Our Ref: BNE210189

Council Reference:	A006608896
Property Location:	607 Lytton Road, Murarrie
Property Descriptions:	Lot 500 on SP337840
Development:	Material Change of Use - Warehouse
Client:	Cannon Hill Developments Pty Ltd

We refer to the Brisbane City Council Information Request dated 25th of October 2024 made under clause 12.1 of the *Development Assessment Rules* ("DA Rules") and, on behalf of our client, and pursuant to clause 13.2(a), forward the following as a **full** response to **all** requested items.

Figure 3 - Original Site Plan (top) and proposed (bottom) - extent of 3m wide landscaping

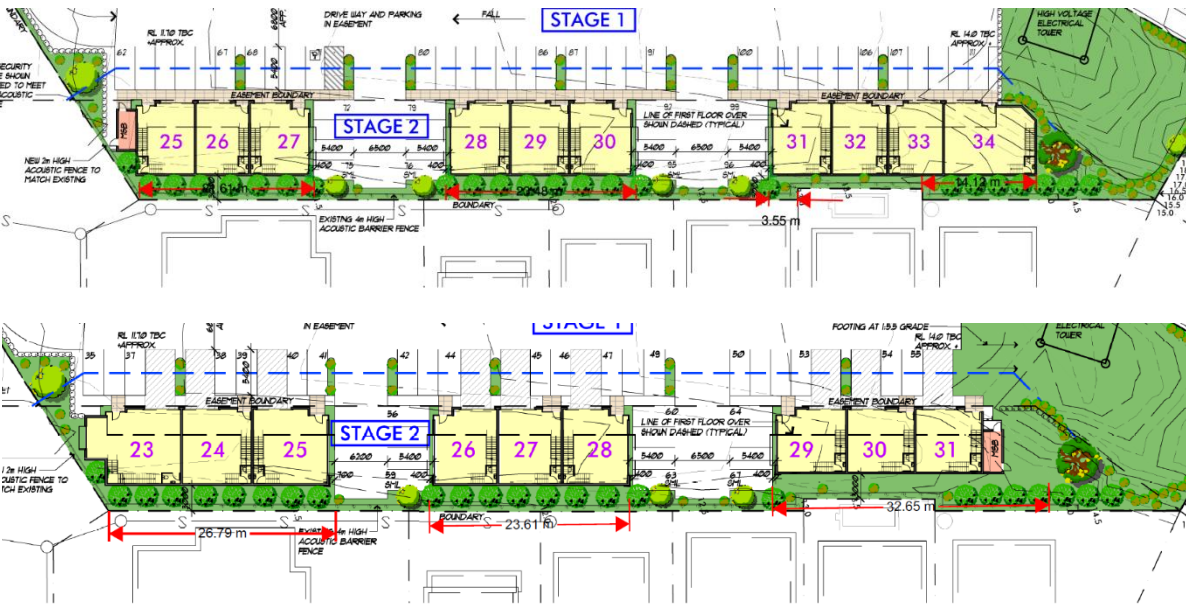
- 3) The proposed landscaping areas between the acoustic fence and the proposed industrial buildings on the south-east boundary are insufficient for the purpose of providing a wide and dense landscape buffer to improve the amenity of the adjoining residential areas in accordance with PO21 /AO21.2 to AO21.4 of the Industry code. Further consideration of the interface to existing residences on Emerald Street is required.*

- a) Provide a minimum 3m or 6m wide densely planted landscaped buffer at the residential interface to comply with AO21.3 and AO21.4 of the Industry code. Garden beds must be wholly located inside the acoustic barrier and exclude areas containing footings. Planting must contain a dense mix of tall trees and shrubs to comply with AO21.4 of the Industry code at the residential interface, as well as to meet the more general requirements of AO12.3, AO12.4, AO12.5 of the Industry code. As planting will initially be obscured by the current placement of the barrier, it must be demonstrated that the garden depths, species selection and density will eventually soften the built form to maintain or improve amenity and to present attractively to the residential areas as intended by PO21 of the Industry code.*

In addition to the above, there has been an increase in the available 3m wide landscaping zone to this interface with repositioning of car parking and the arrangement of the tenancies. Former units 31 to 34 (now Units 29-31) have seen an increase in the setback to 3m from the boundary of the site and 83 Emerald Street. Effectively, this affords an increased separation between these units and the dwellings at 81 and 85-93 Emerald Street and increased planting width above 3m in part, refer **Figure 3** below. The extent of the width of the 3m landscaping buffer has been increased from around 64m to 81m, greatly increasing the ability to provide a planted buffer in a 3m planting area along a greater extent of the interface.
